I-195 Relocation - Contract 15 (East side city streets)

NOTICE TO PROSPECTIVE BIDDERS

ADDENDUM NO. 2 Prospective bidders and all concerned are hereby notified of the following changes in the Plans, Specifications, Proposal and Distribution of Quantities for this contract. These changes shall be incorporated in the Plans, Specifications, Proposal and Distribution of Quantities, and shall become an integral part of the Contract Documents.

DESIGNED BY:
 CHECKED:
 DATE:
 SHEET: V1_028
 OF: V1_165

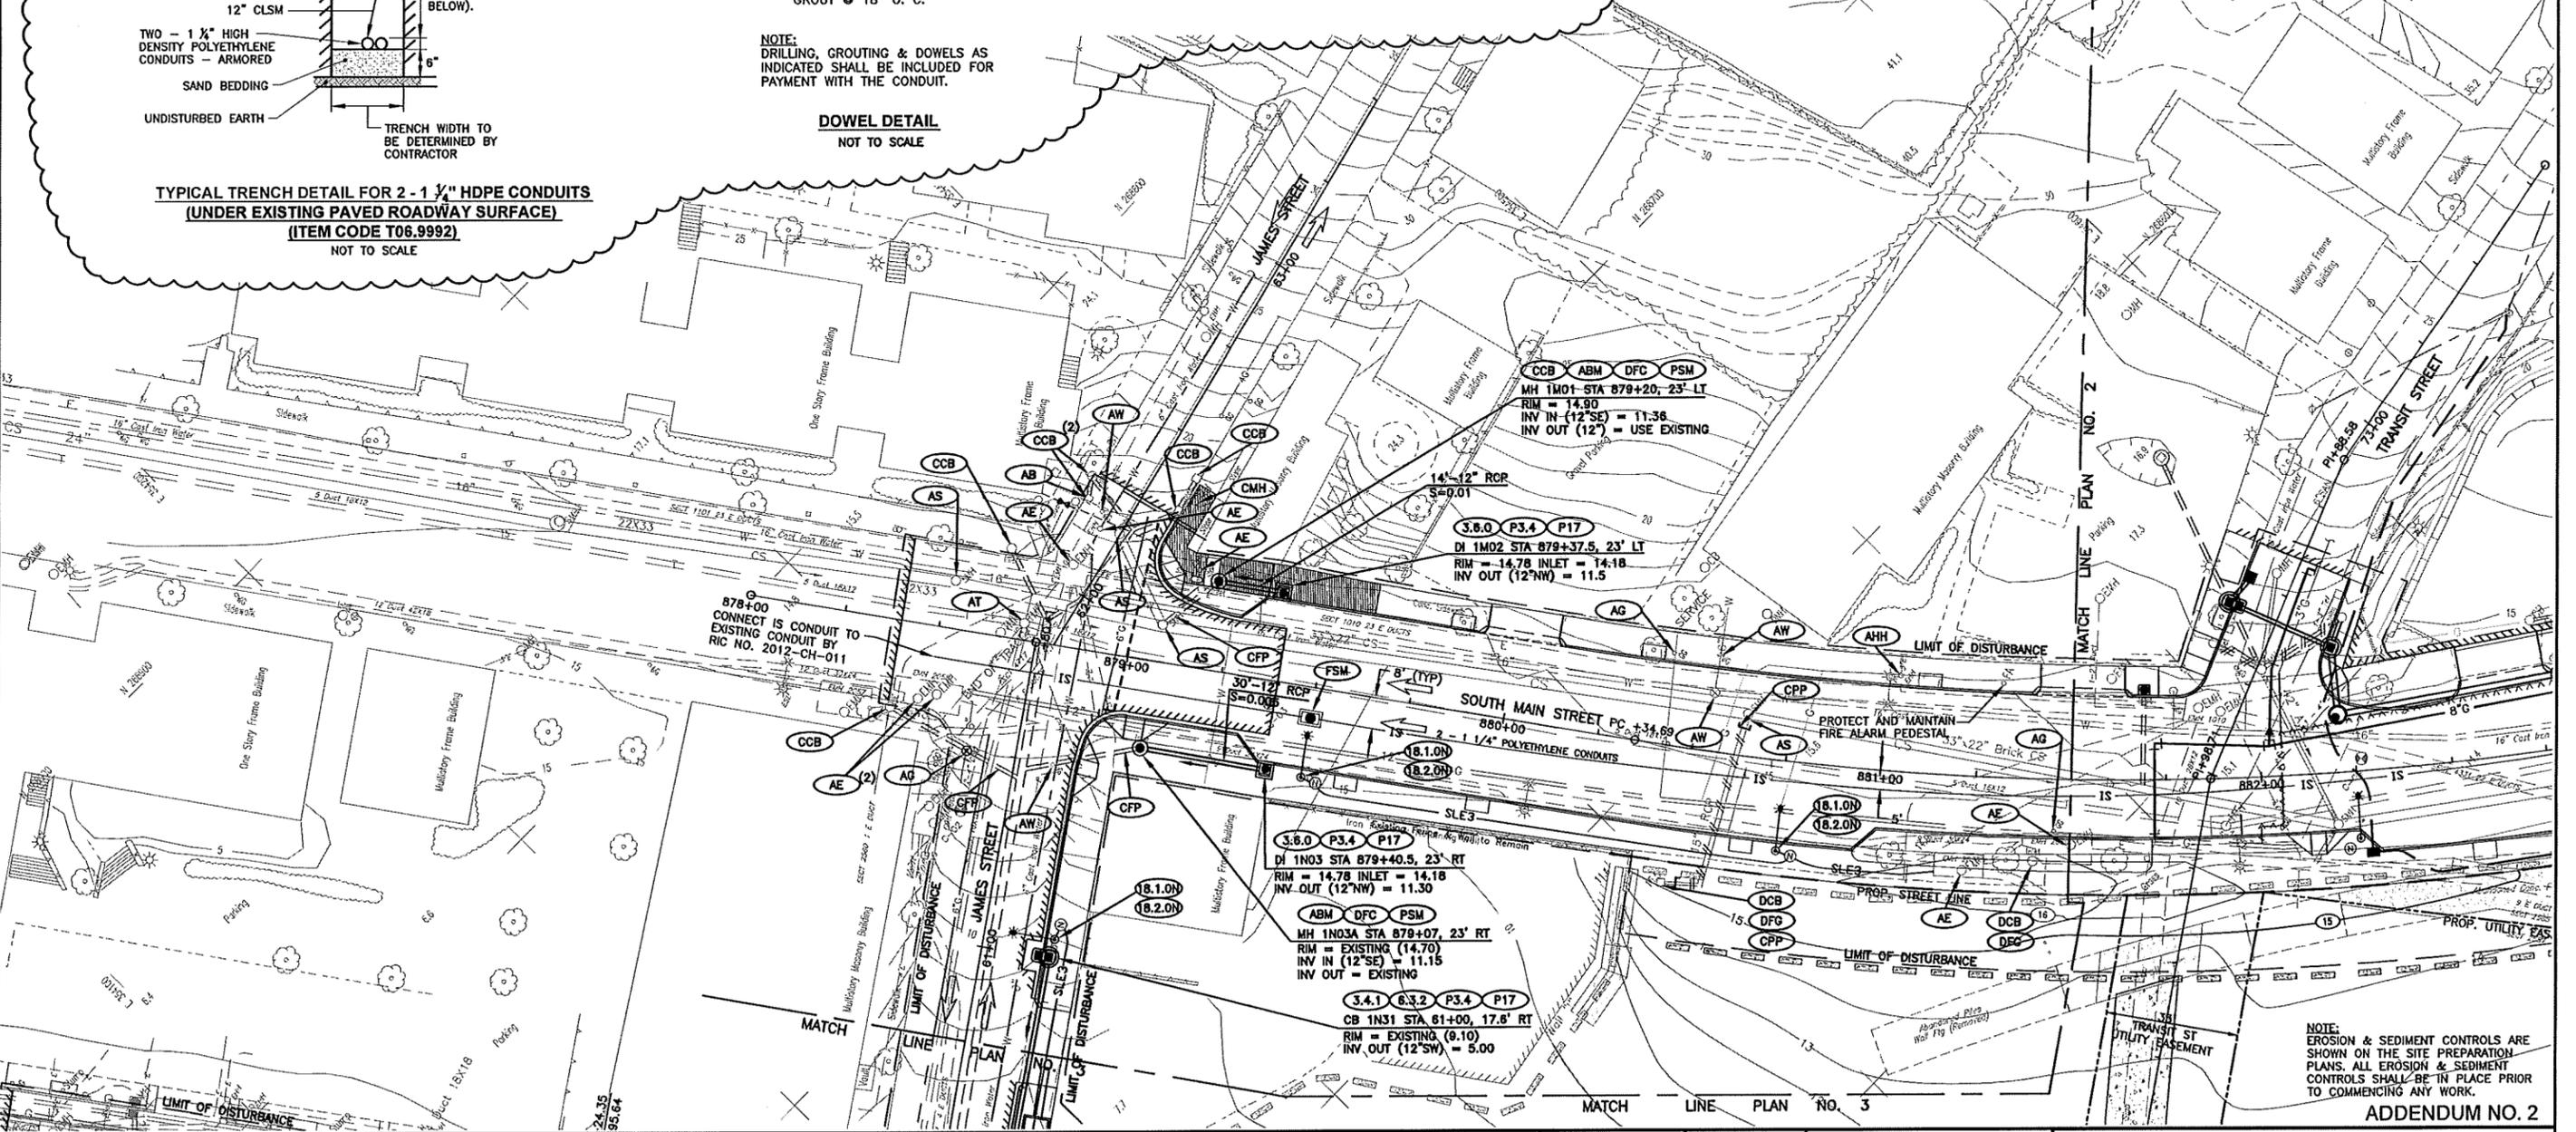
Delete Sheet V1_028 in its entirety and replace it with Sheet V1_028(R-1) attached to this Addendum No. 2. Trench details have been added.

DESIGNED BY: CC
 CHECKED: KC
 DATE: MARCH 2013
 SHEET: V1_116
 OF: V1_165

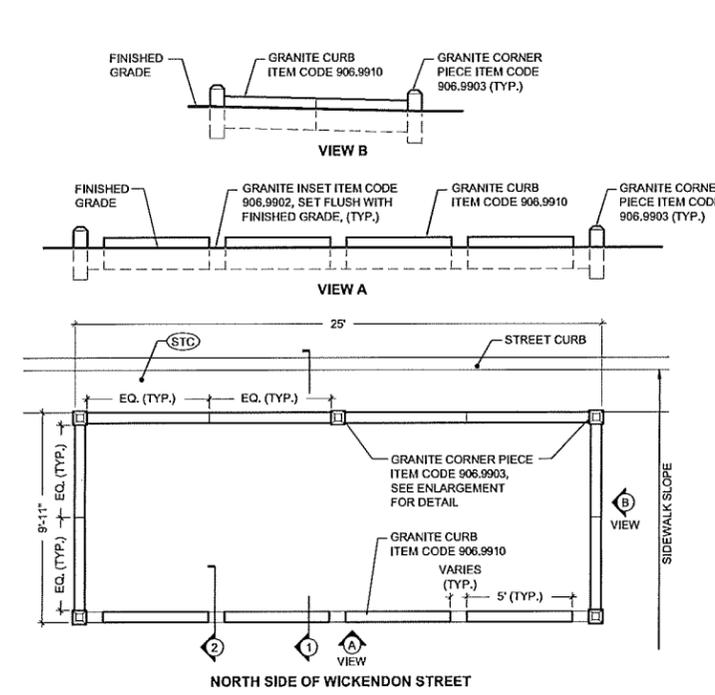
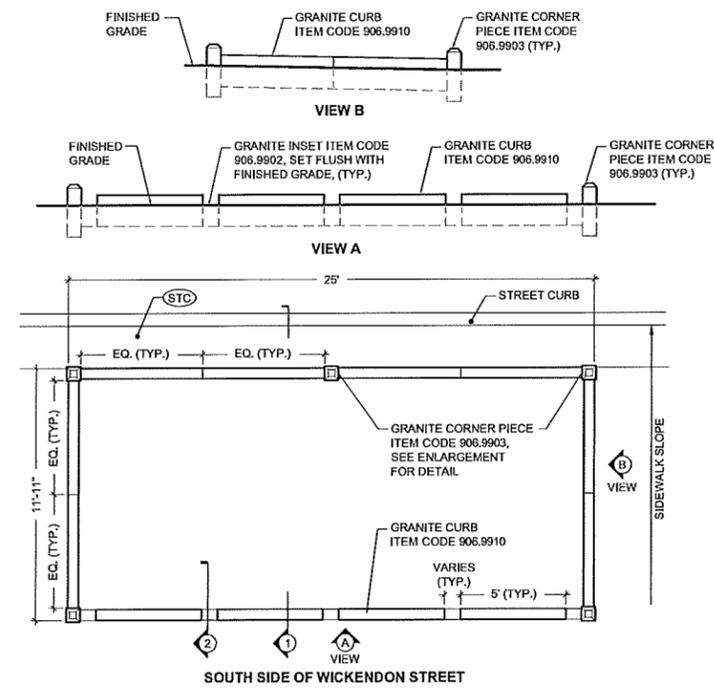
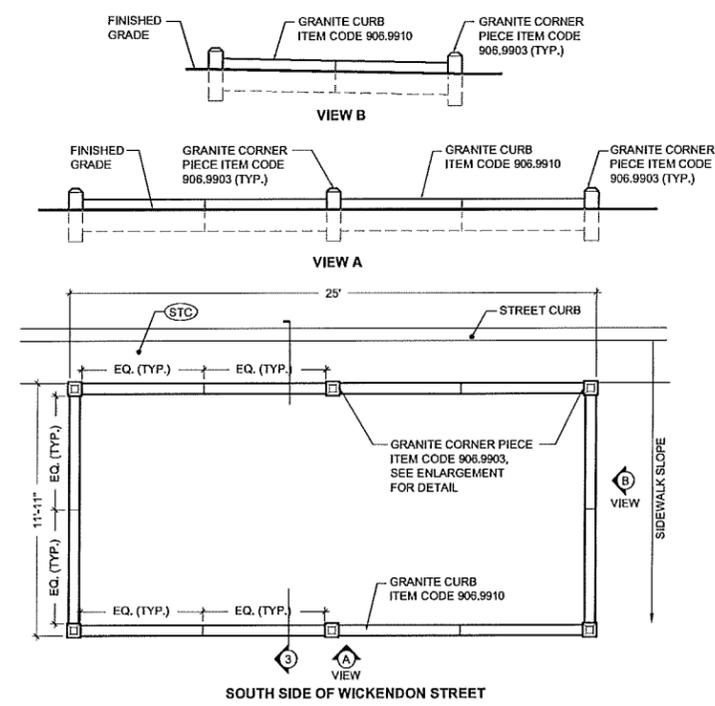
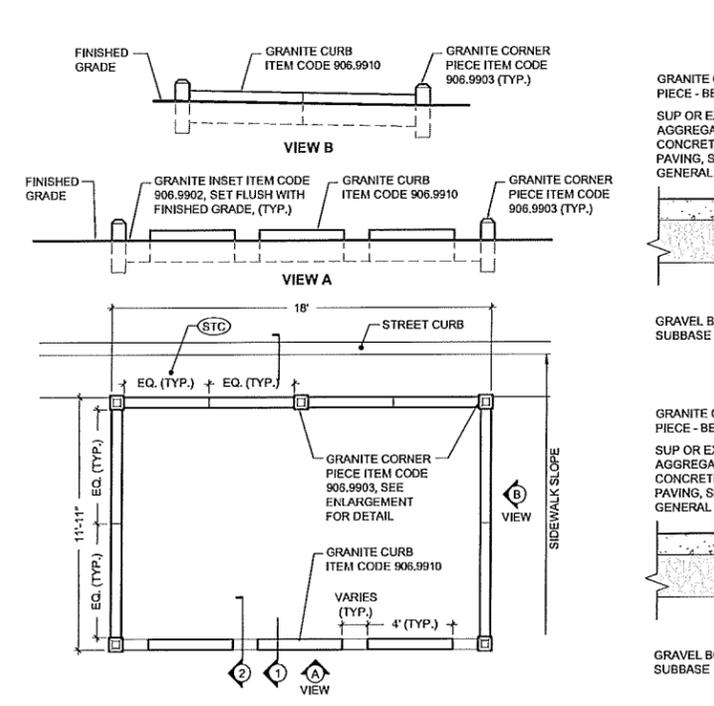
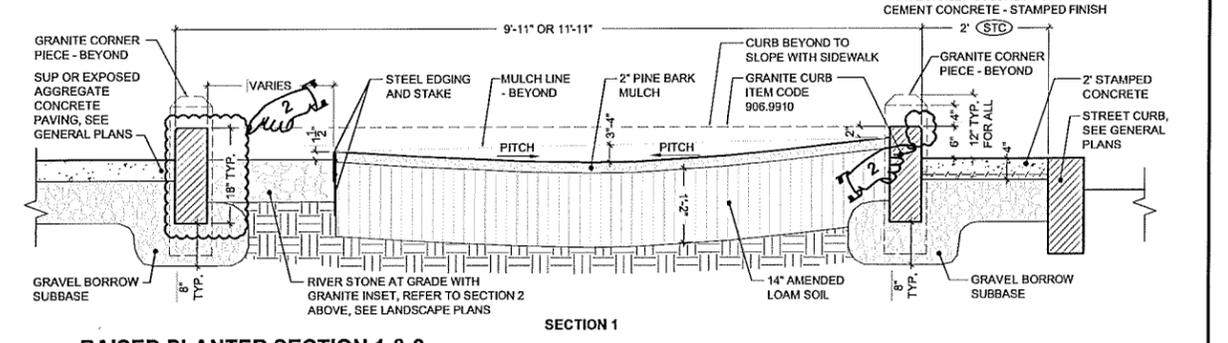
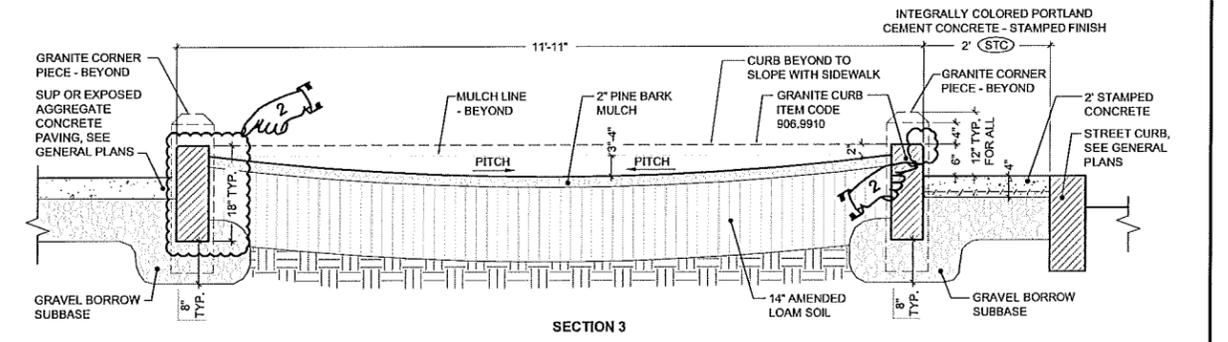
Delete Sheet V1_116 in its entirety and replace it with Sheet V1_116(R-1) attached to this Addendum No. 2. Planter Curb details have been revised.
